ADDENDUM #1

FISHBECK ADDENDUM NO. 1

Well Station 11 Filter Improvements

91392-003.0

Sheet: P202 - PIPING AND EQUIPMENT SECTIONS (reissued)

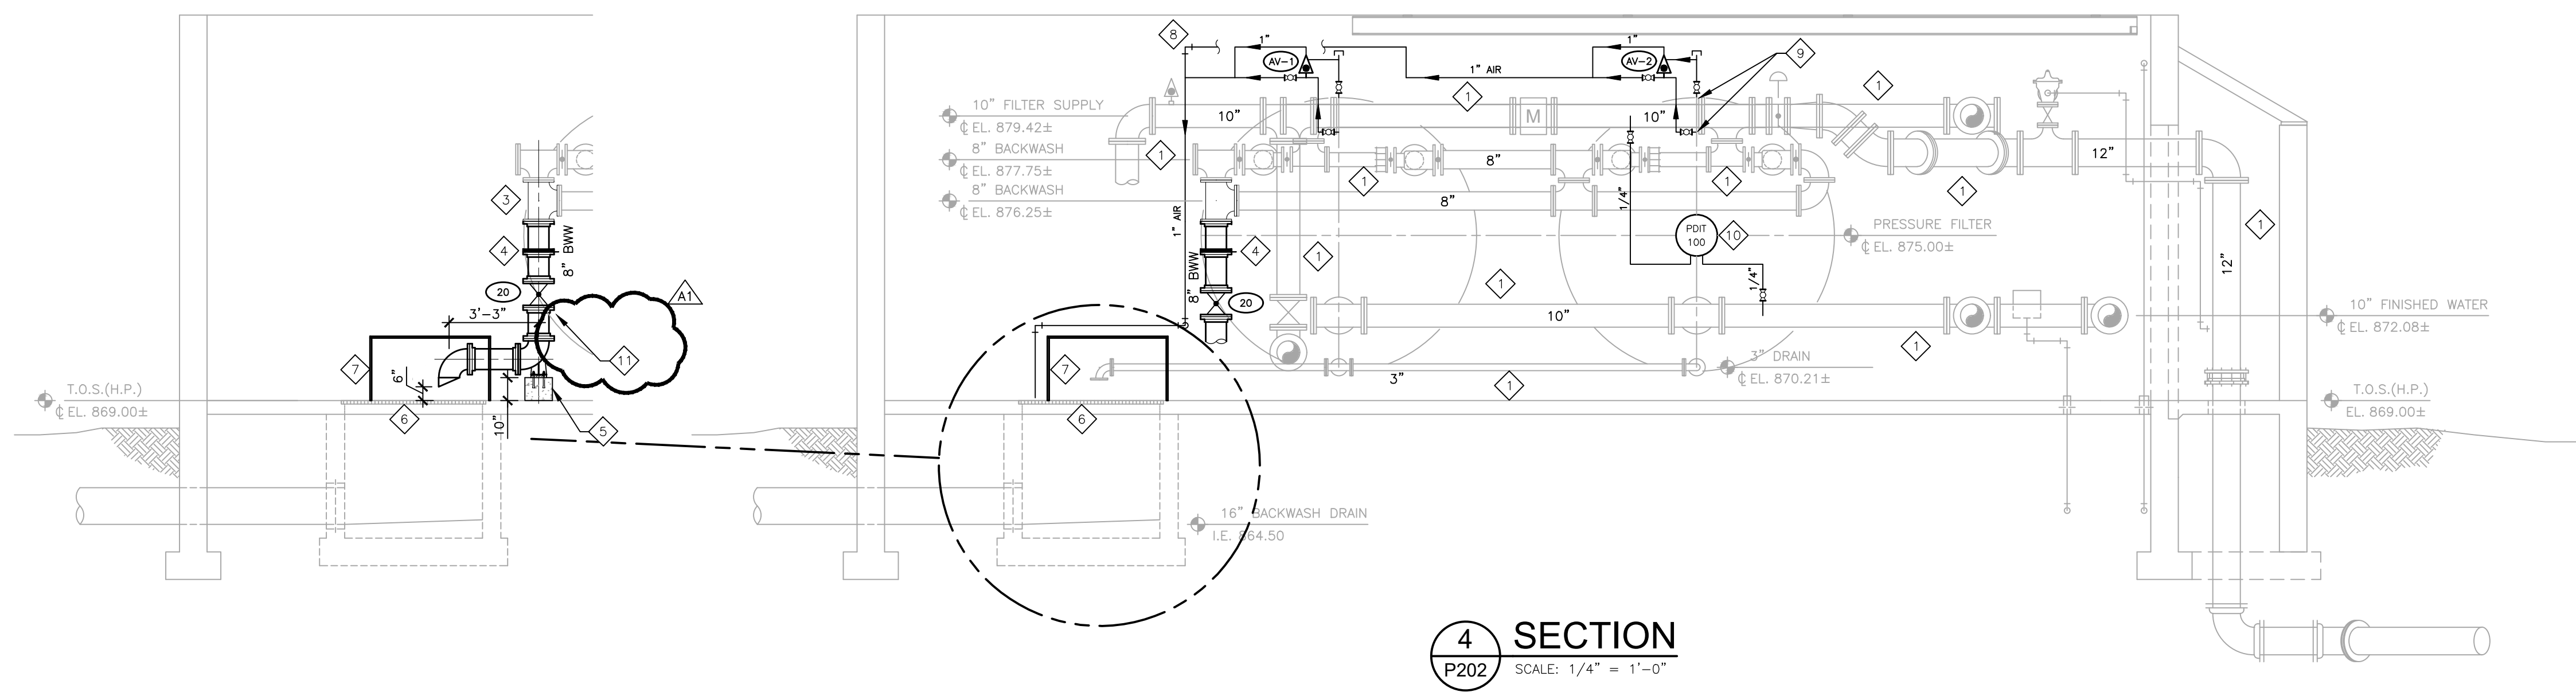
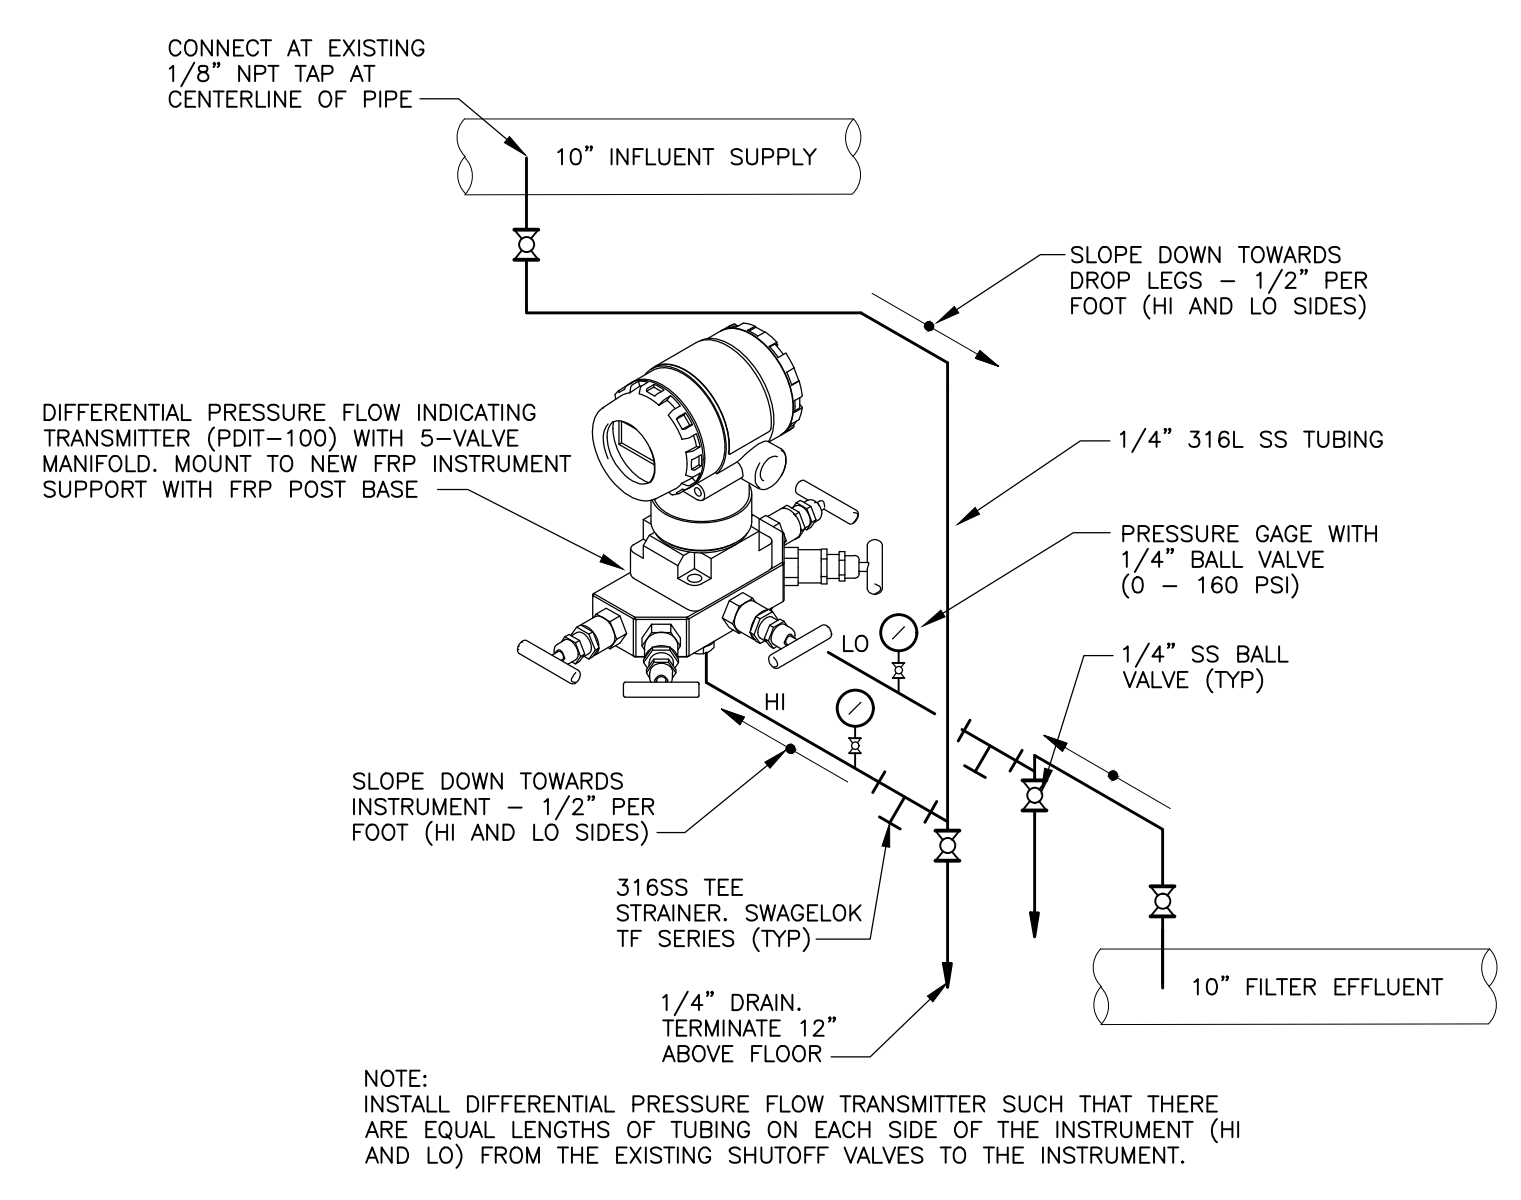
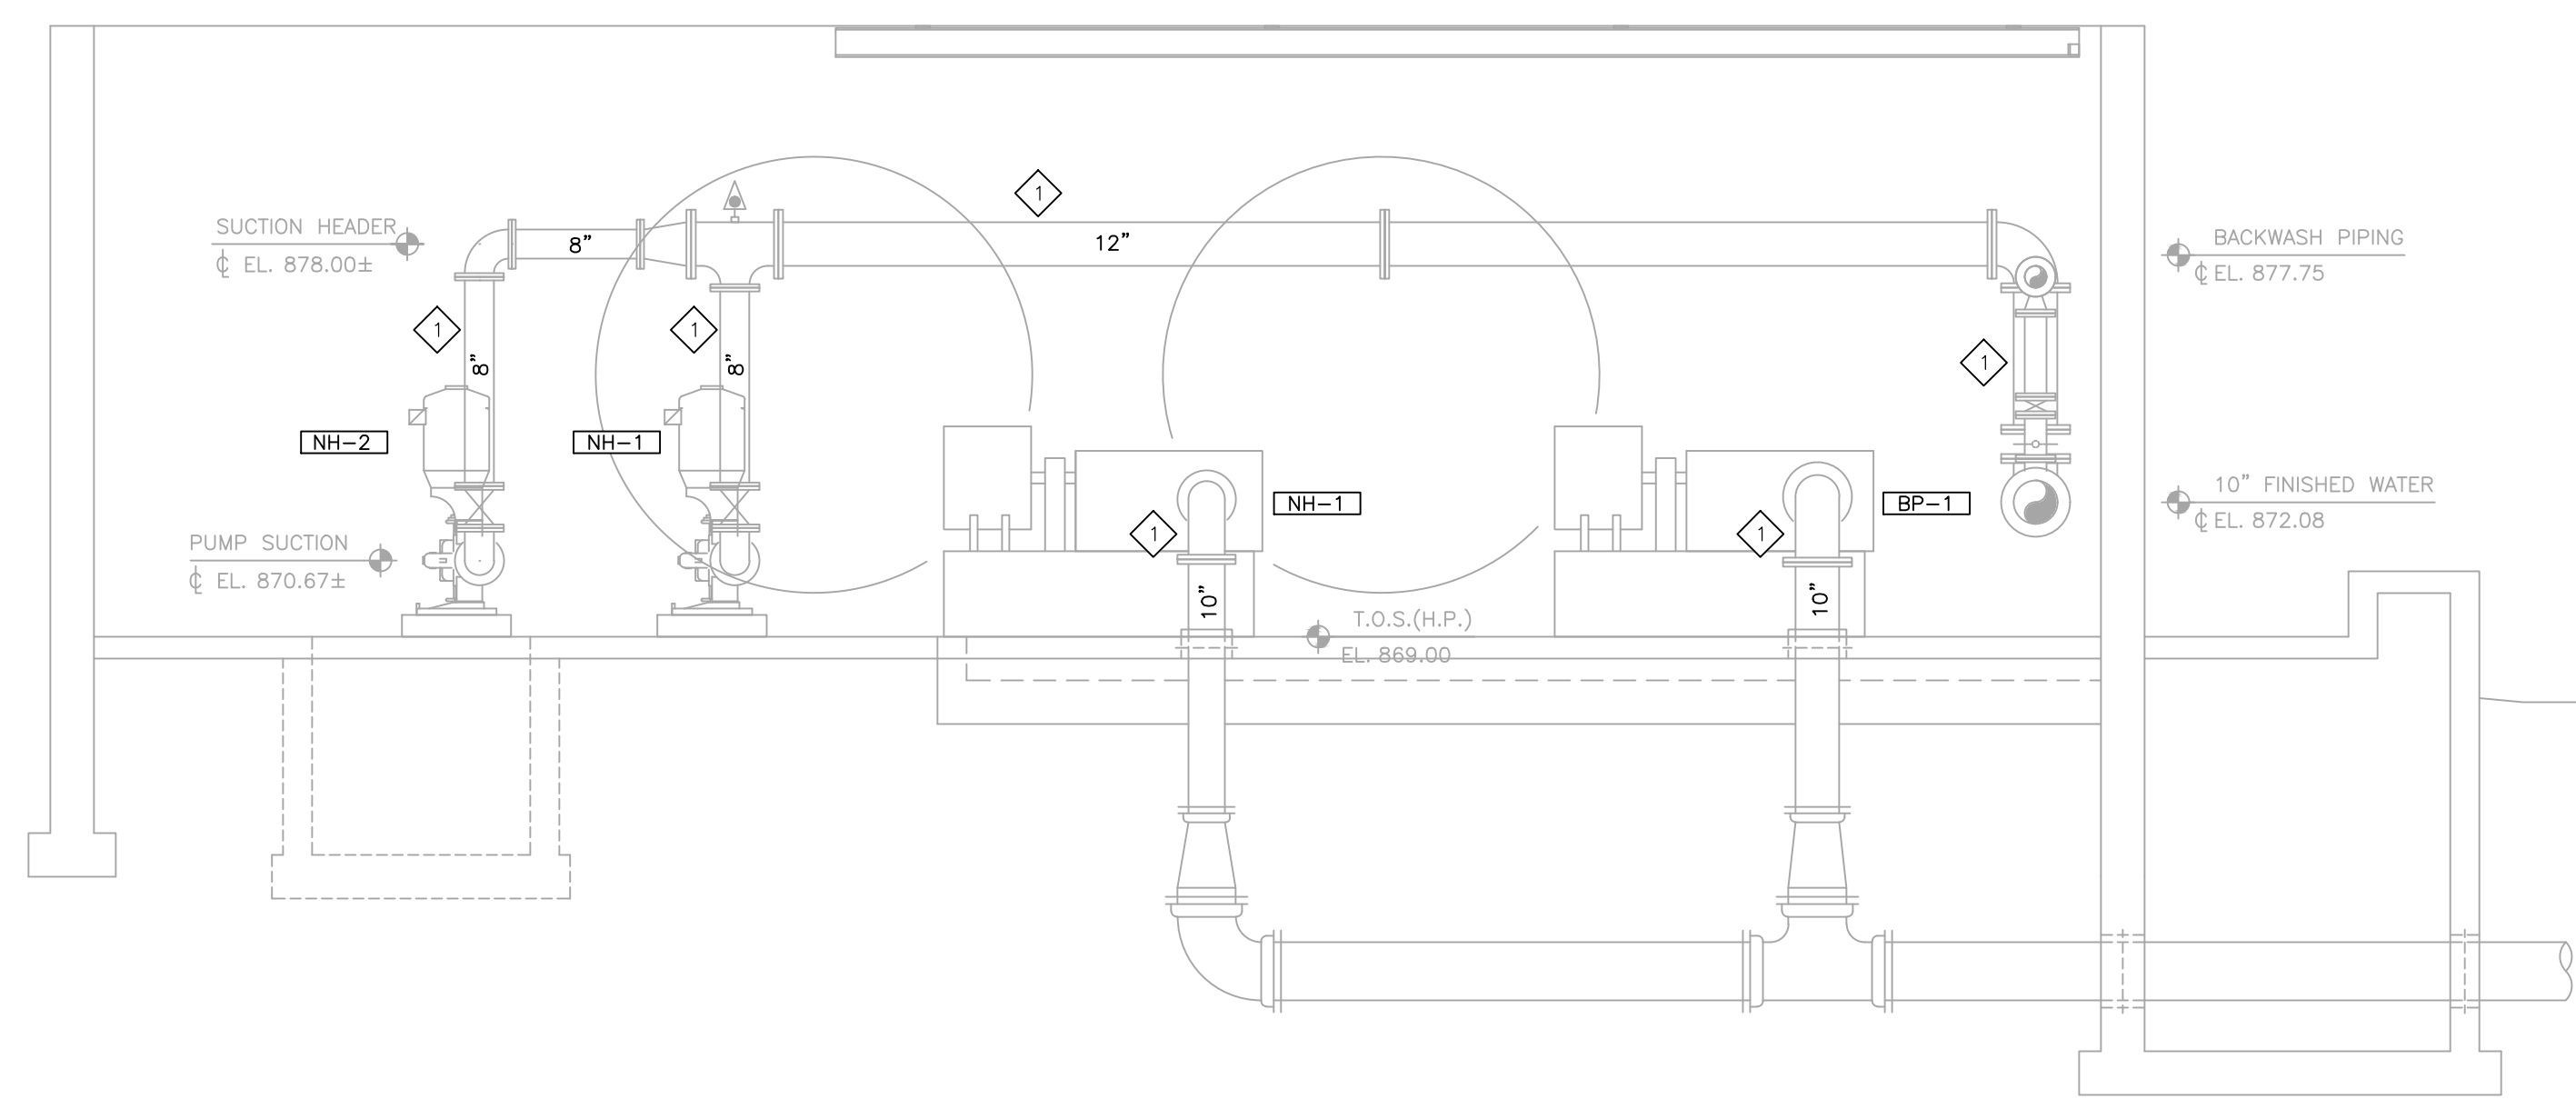
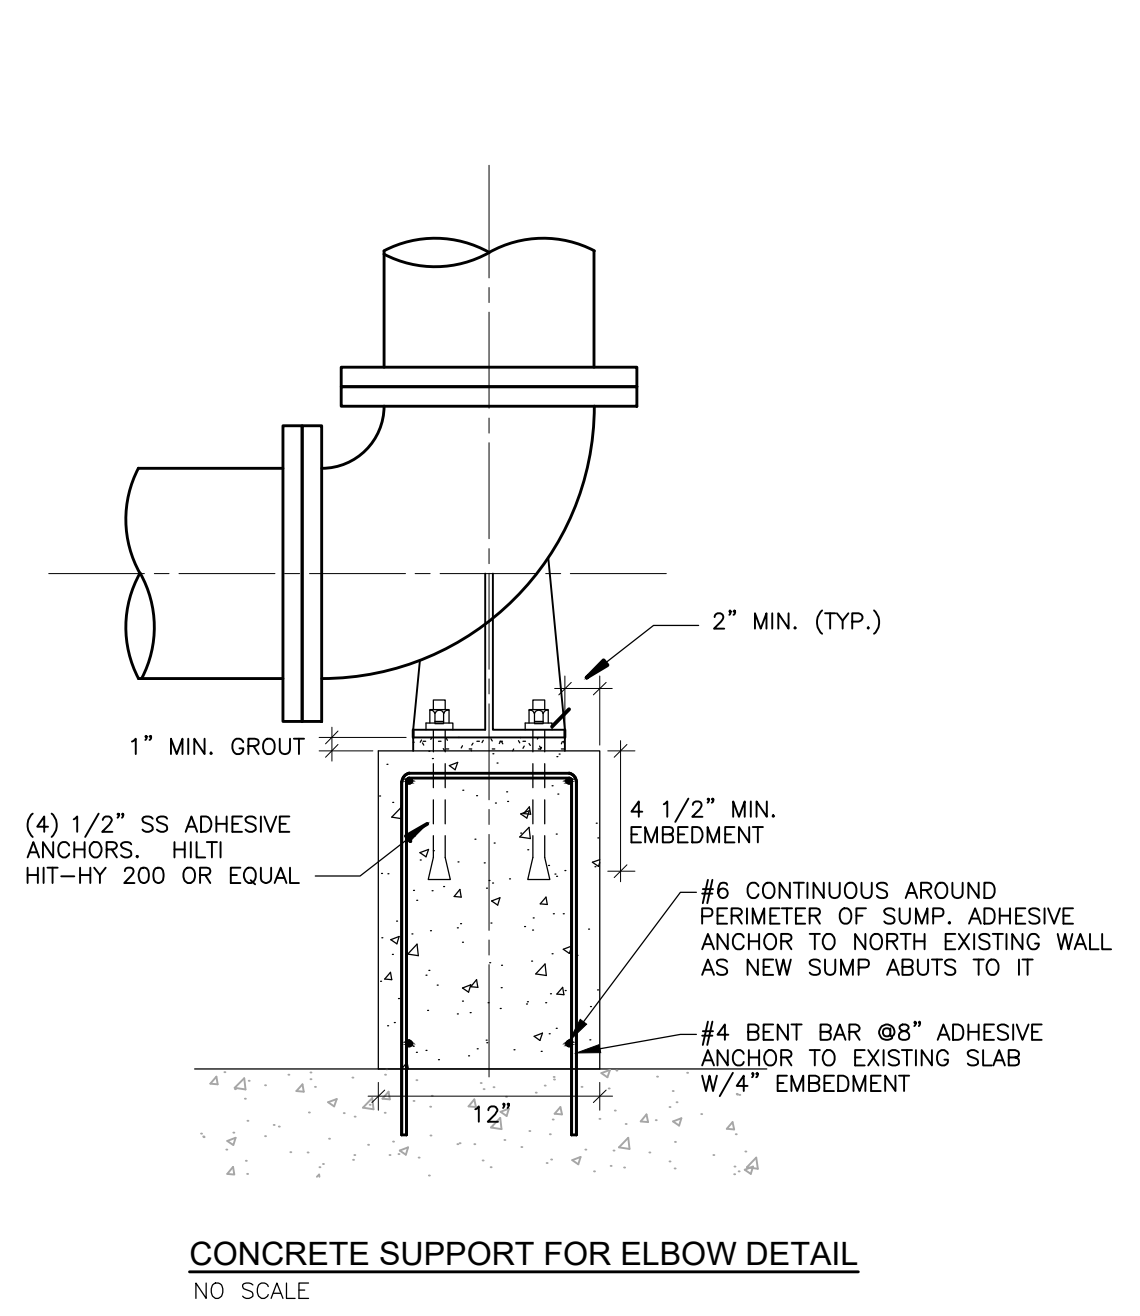
A. Add Keynote 11:

11. Relocate and reconnect three existing electrical conduits and conductors in this area where new 8" pipe is routed. Coordinate with City on shutdown of equipment these conductors supply during work.

11. RELOCATE AND RECONNECT THREE EXISTING ELECTRICAL CONDUITS AND CONDUCTORS IN THIS AREA WHERE NEW 8" PIPE IS ROUTED. COORDINATE WITH CITY ON SHUTDOWN OF EQUIPMENT THESE CONDUCTORS SUPPLY DURING WORK.
